Re: Fairmont Hot Springs Resort Area,
Flood Protection Works Inspection

RE: Flood Protection Works Inspection – Fairmont Creek

RE: Flood Protection Works Inspection – Coldspring Creek Downstream of Highway 93

Photo 3, Coldspring Creek Debris Trap

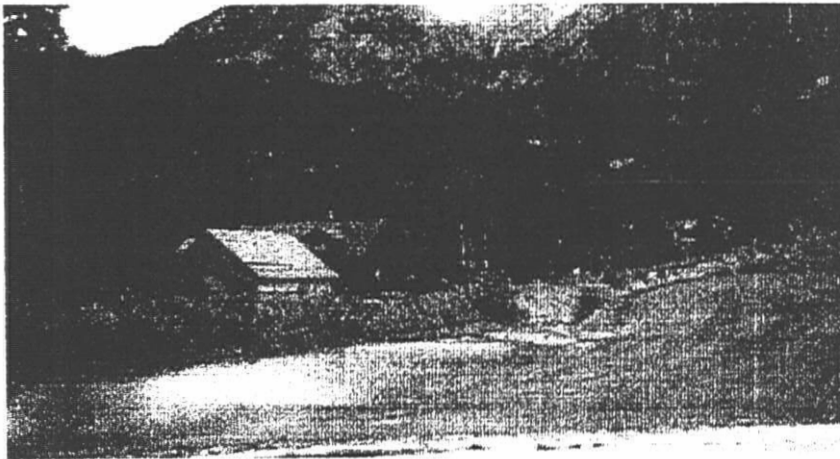
The debris trap adjacent to the Columbia River is almost free of sediment and debris accumulation. **Photo 3** shows the general condition of this facility.

At this time we recommend only continued monitoring of this system which includes Coldspring Creek downstream of Highway 93 and the debris trap adjacent to the Columbia River.
